**SUNDRY NOTICES AND REPORTS ON WELLS**  
**Do not use this form for proposals to drill or to re-enter an abandoned well. Use Form 3160-3 (APD) for such proposals.**

8. Well Name and No.  
East Blinebry Drinkard Unit (EBDU) #096 (35023)

9. API Well No.  
30-025-39677

Add Blinebry I Pay & Acidize

WELL DATA SHEET

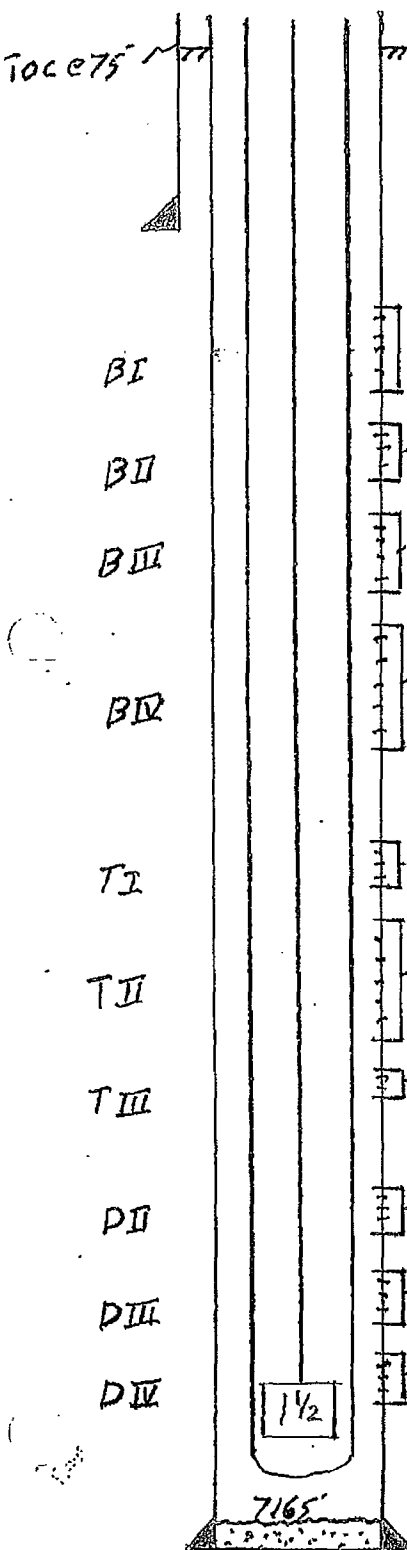
↑ operator to remain within the Blinebry, Drinkard,  
+ Tubbs. → Blinebry top is @ 5862.

5. RU wireline truck. Correlate to the Gray Wireline Compensated Neutron/Gamma Ray/CCL log run on July 8, 2010. *top @ 5862' See CORAS*
  - a. Perf (Blinebry I) : 5851', 53', 55', 57', 59', 87', 89', 91', 93', 95', 97' & 99' w/2 spf, 120 deg phasing. (Total = 24 shots).

**Note: Blinebry top is at 5862' per completion report. Operator shall not perf above this zone as they do not have approval.**
